**RE: COMMENTS CONCERNING THE PROPOSED NEAR SURFACE
DISPOSAL FACILITY PROJECT AT THE CHALK RIVER LABORATORIES**

CEAA Reference number 80122

Comments on the draft Environmental Impact Statement
CEAA #80122

Prepared by Wilf Ruland (P. Geo.)

Figure 1 - Chalk River Surface Water Monitoring Stations

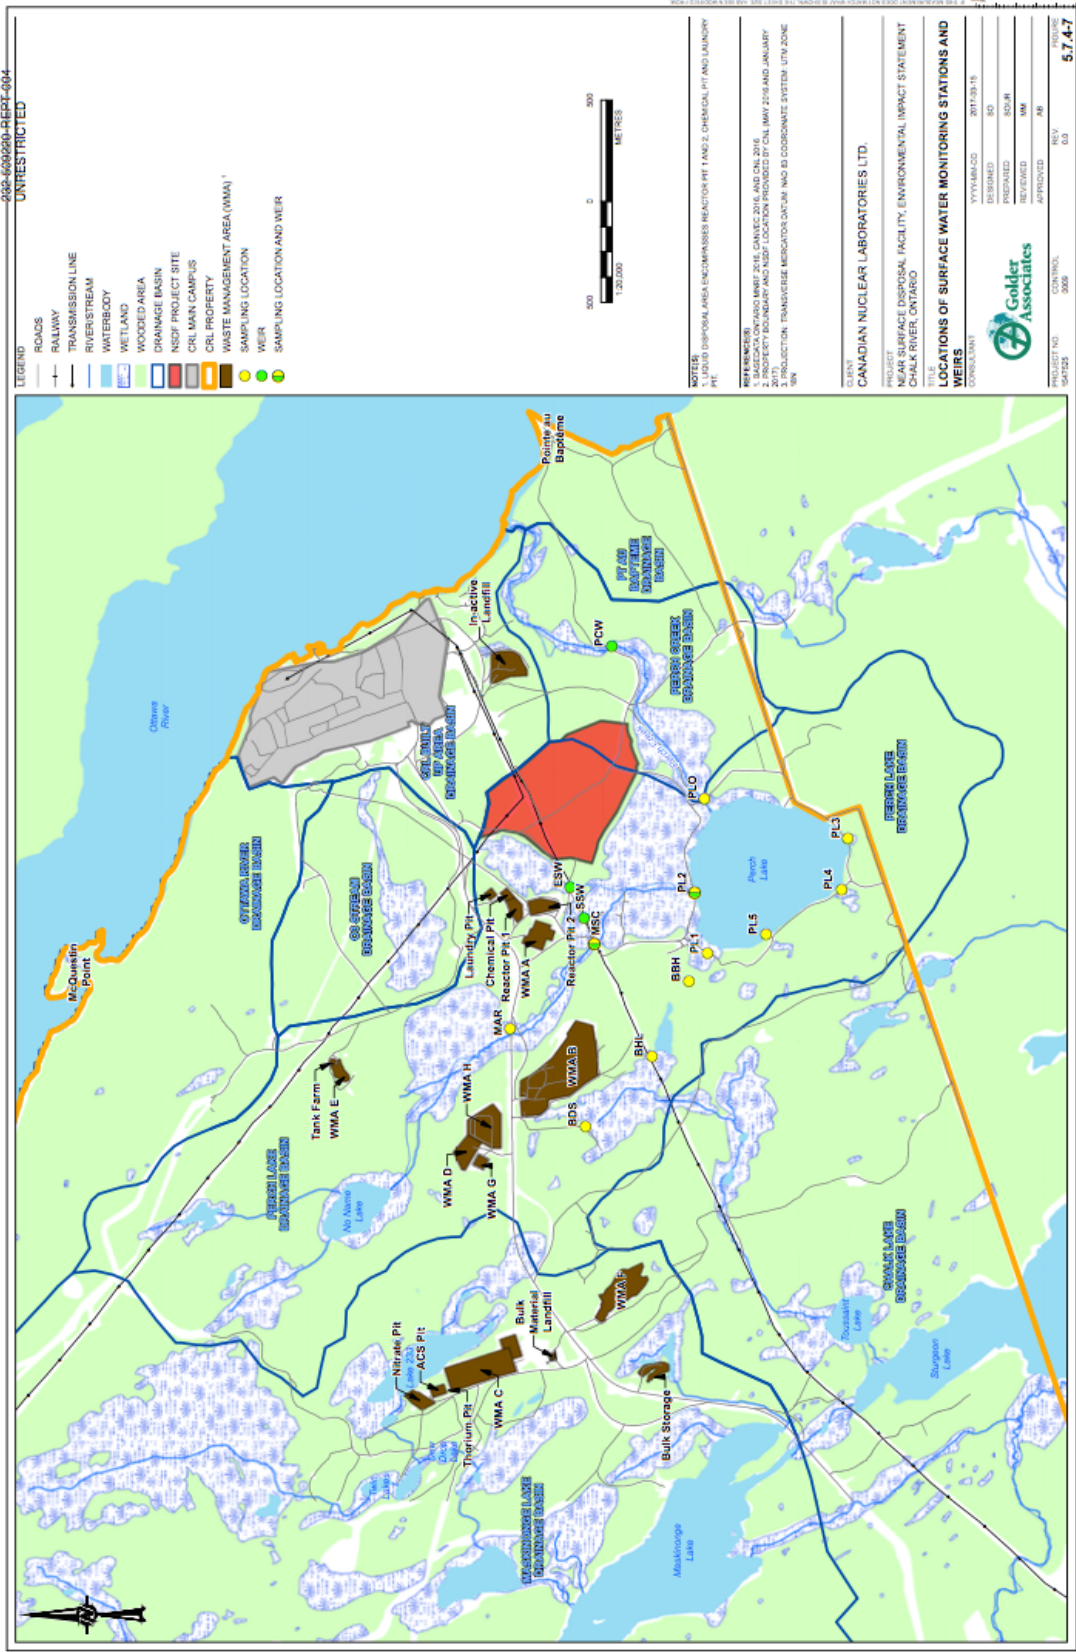
<u>Monitoring Locations</u> (see Fig. 1 on next page)	<u>Tritium Levels</u>	<u>Reference</u>
Current Tritium Levels on Undeveloped NSDF site	<64 to 155 Bq/L	p. 5-481
Tritium Levels in Groundwater in East Swamp	no disclosure provided in draft EIS	
East Swamp Weir (ESW)	359 Bq/L	Table 5.7.4-8
Perch Lake Inlet (PL2)	2,438 Bq/L	Table 5.7.4-8
Perch Lake Outlet (PLO)	3,879 Bq/L	Table 5.7.4-8
Perch Creek - Weir (PCW)	3,374 Bq/L	Table 5.7.4-8

High tritium levels are already present in Perch Lake and Perch Creek, as shown in Table 5.7.4-8, which shows average tritium levels in these surface waters of several thousand Bq/L. This means that there is only a limited capacity for addition tritium loading if the draft EIS commitment to an upper limit in Perch Creek of 7,000 Bq/L (which is based on the PWQO for tritium) is to be respected.

Instead of just providing average levels, seasonal high and low tritium levels should have been presented in the draft EIS. My sense is that there will be times (perhaps during drier summer base flow periods) when the creek is already at or near the 7,000 Bq/L limit for tritium, implying that the addition of tritium-laced WWTP effluent will push the creek over the limit.
